WPF4 - Reworking Control Line for Exhaust Flaps (Workshop Campaign)

Revision: This bulletin replaces bulletin Group 2 58/23 WPF4, dated June 30, 2023.

Vehicle Type: **718 Cayman GT4 RS (982)**

Concerns: **Control line for exhaust flaps**

Oil filler pipe

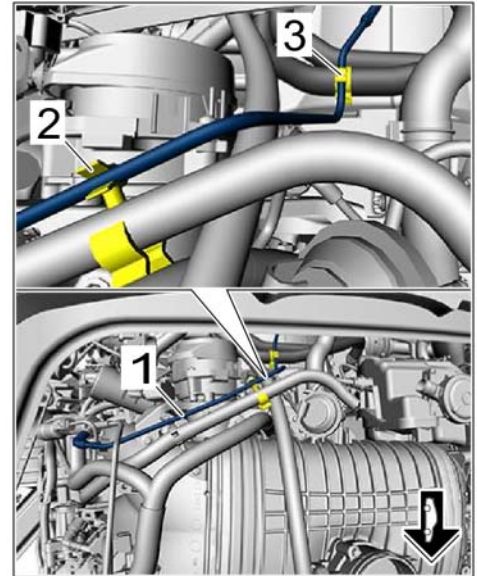
- 2 Disconnect oil filler pipe ⇒ *Oil filler pipe -1-*.
- 2.1 Releasing and disconnecting quick connector
⇒ *Oil filler pipe -Arrow-*.
- 2.2 Close off line connections using suitable stoppers.

Control line for exhaust flaps

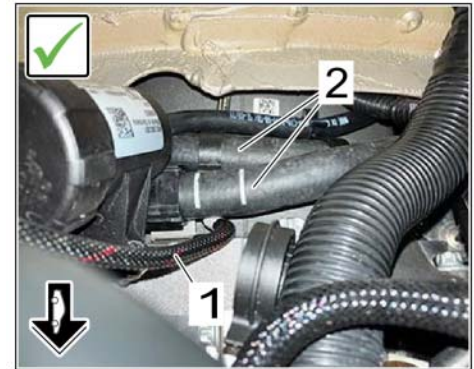
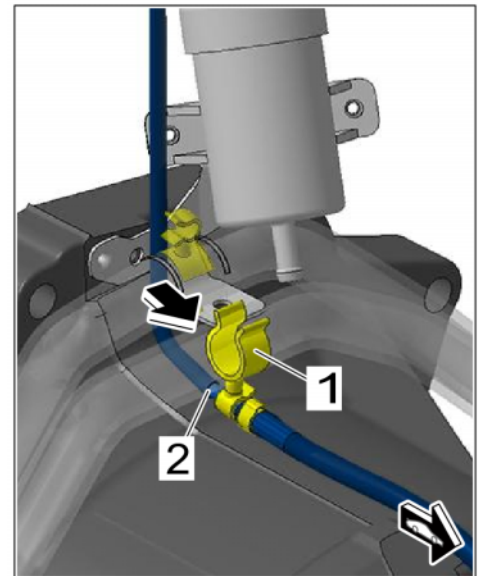
- 3 Disconnect control line for exhaust flaps ⇒ *Control line for exhaust flaps -1-* at the change-over valve and unclip it from holders ⇒ *Control line for exhaust flaps -2-* and ⇒ *Control line for exhaust flaps -3-*.

- 4 Guide control line for exhaust flaps ⇒ *New positioning of control line for exhaust flaps -1-* **under** the cooling center hoses ⇒ *New positioning of control line for exhaust flaps -2-*.

Previous position of control line for exhaust flaps

*New positioning of control line
for exhaust flaps*

The steel flex line must be positioned to the right of the transmission center.

Coolant hose holder

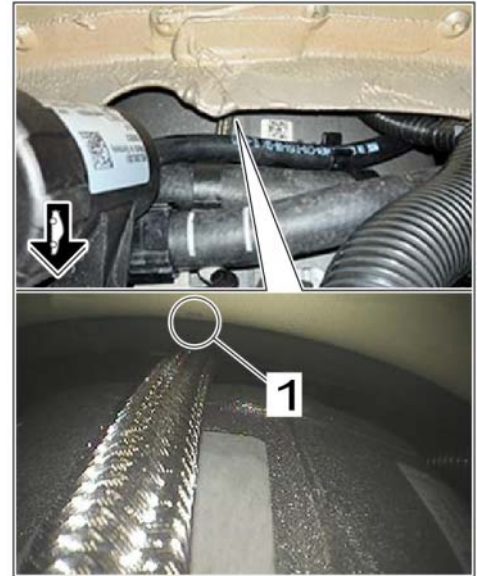
- 5 Re-position holder ⇒ *Coolant hose holder -1-* on **another coolant hose**. Push the sleeve back and clip control line for exhaust flaps ⇒ *Coolant hose holder -2-* into the holder.

Adhesive pad on body

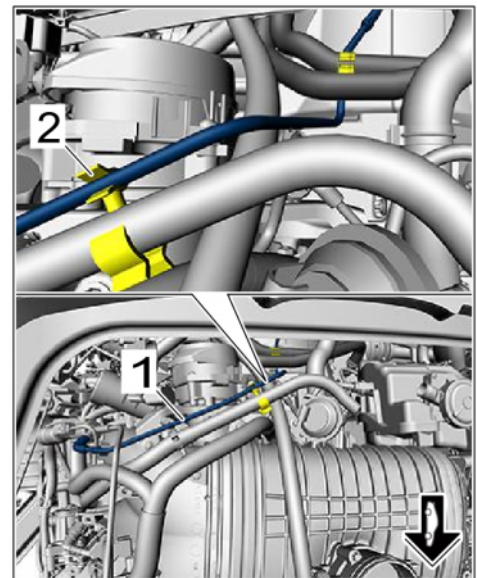
- 6 Apply adhesive pad at the bottleneck ⇒ *Adhesive pad on body-1* - above the control line on the body.

Control line for exhaust flaps

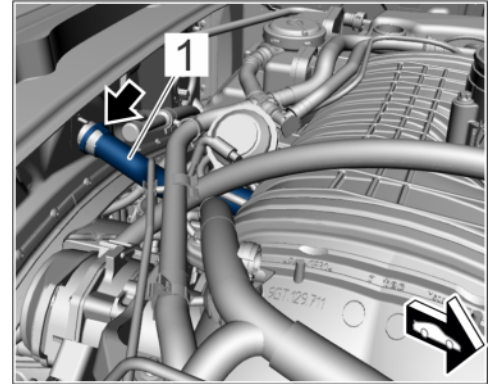
- 7 Connect control line for exhaust flaps ⇒ *Control line for exhaust flaps-1* - to the change-over valve and clip ⇒ *Control line for exhaust flaps-2* - it into the holder.
